# Service Bulletin

JANUARY

1961

NO. 359

FIG. 2

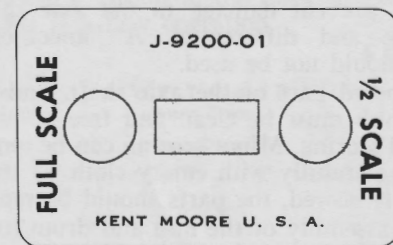
NOTE—Due to a manufacturing error, the switch positions on the early production J-9200 Testing Units were incorrectly labeled. The Full Scale and the 1/2 Scale positions on the face of the gage were reversed.

The error was corrected in production. The corrected test units are identified with the number J-9200-01 and operate as indicated on the face of the unit. Figure 2 shows a J-9200-01 decal that can readily be applied to the J-9200 Test Unit. If your test unit is identified as a J-9200, notify the Technical Section, Parts & Service Division, and the correct decal will be sent to you at no charge.

FIG. 3

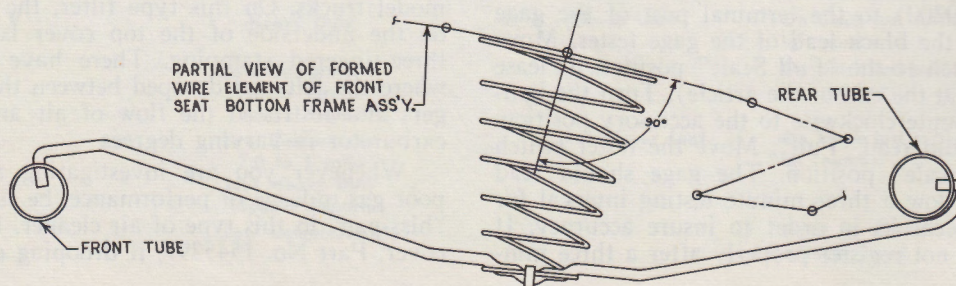
Beginning with the 1961 Y1 model Taxicabs, the driver's side of the front seat will be equipped with a Part No. 1340335 Support and Coil Assembly, as standard equipment.

Installation of the new Support and Coil Assembly can be made on prior Y1 models by using the following procedure.

6. Again measure 3-3/4" to the right and scribe an additional mark.
7. Center punch at each of these 3 locations and drill 1/4" holes through the outer wall of the tubing, holding the drill on a horizontal plane. (See Fig. 3.)

1. Remove front seat assembly.
2. Remove seat back rear panel.
3. Loosen trim cover along lower front edge of seat frame by removing hog rings. Turn back upholstery-trim cover sufficiently to expose the tubular seat frame at the front lower edge of driver's seat.

4. Measure 2-5/8" to right of seat track bracket, along the tubular frame at the rear of the driver's seat, and scribe a mark.
5. Measure 3-3/4" to the right of this mark and scribe another mark on the tubular frame.

8. Insert the three hooked wire ends of the "basket" in the holes, with coil springs facing under side of seat.
9. Move the basket into position so that the forward wire ends of the "basket" rest on top of tubular frame at front of seat.

10. In this position the angular wire ends will indicate locations to drill three 1/4" holes into which the wire ends will fit and lock the basket in position.

11. Secure the coil springs to the zig-zag seat elements with hog rings, adjusting for best position to attach.
12. Re-attach upholstery trim and install seat back rear panel.

FIG. 4

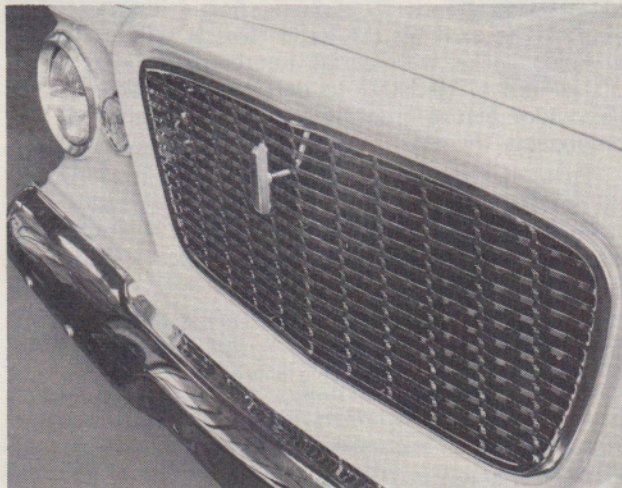
Beginning with Serial No. 61S-7623, an external hood lock control entered production on Y1 (Taxicab) models. The parts involved are as follows:

This arrangement can be readily installed on prior production taxicabs. In addition to the above parts, modify the grille as required to accept the change in the handle location. (See Fig. 4).

FIG. 5

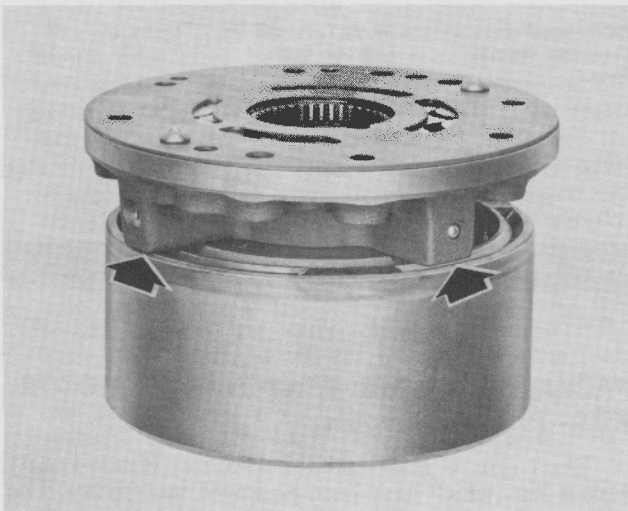
To insure against interference between the welds on the back of the high range clutch housing and the ribs on the front pump when installing a new housing, check the clearances prior to installation as follows:

Contact of high weld points on the clutch housing of the pump rib produces a clicking noise when engine torque is applied in low or reverse.

Place the correct thrust washer, or thrust bearing combination on the front pump hub for the model involved and install the clutch housing on the pump hub. With a feeler gauge, check the clearance of the three welds to the pump ribs, Fig. 5, by rotating the housing. The clearance should not be less than .050" minimum for any of the welds. If any of the welds have a clearance less than the minimum stated, grind off the high spots only of the weld or welds involved. Remove only the necessary amount of weld required to produce a minimum clearance at the welds.

FIG. 6

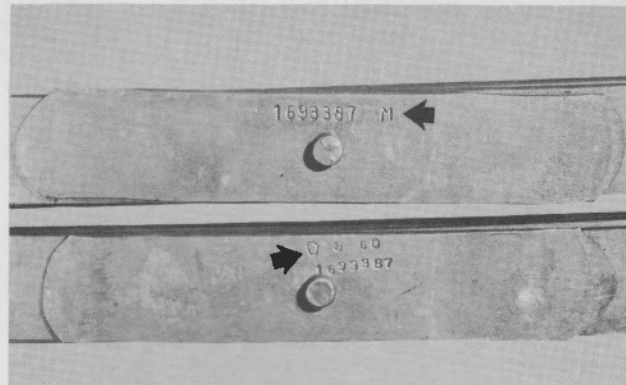
In the beginning of 1961 truck production the front spring assembly for the 6E5 and 6E10 Heavy Duty and the 6E7 and 6E12 standard spring, Part No. 1693387, was supplied by two vendors. One used the letter 'M' for identification, the other a Keystone symbol. The identification mark is located on the short leaf adjacent to the spring center bolt. (See Fig. 6.)

The spring with the Keystone symbol has a considerable difference in carrying height than the assembly identified by the letter 'M'. It will be necessary on trucks with serial numbers prior to 6E5-130412 and 6E10-39031 to determine the identity of the vendor before ordering a spring assembly or the components thereof.

To service the Front Spring, Part No. 1693387, on trucks with serial numbers prior to those listed above and having the Keystone symbol, order Front Spring Assembly, Part No. 682829, or its respective leaves as listed in the Parts Catalog.

To service the front springs bearing the letter 'M' identification mark, order the Spring Assembly, Part No. 1693387, or its respective leaves as follows:

To service Front Spring Assembly, Part No. 1693388, with the Keystone symbol, order Spring Assembly, Part No. 682830, or its respective leaves as listed in the Parts Catalog.

FIG. 7

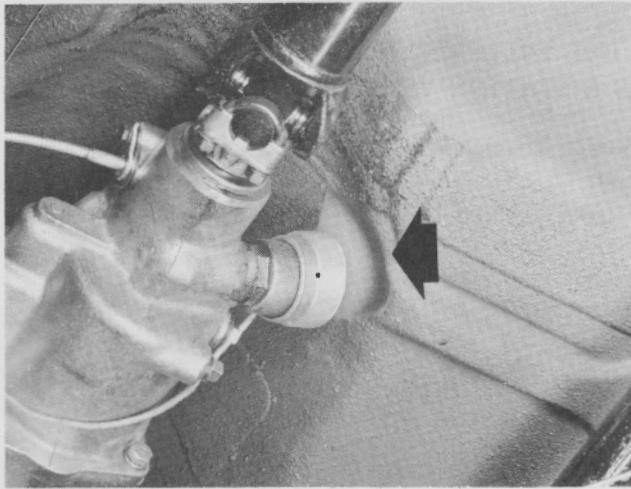
In some instances the overdrive governor may interfere with the floor pan when attempting to remove the governor from the transmission. In such cases a ready remedy to the problem is to take a caulking iron and relieve the floor pan in the area adjacent to the governor. Figure 7 shows the area to be relieved. A similar correction is being made in production beginning with Serial Nos. 6E5-130484, 6E7-14460, 6E10-39034 and 6E12-4758.
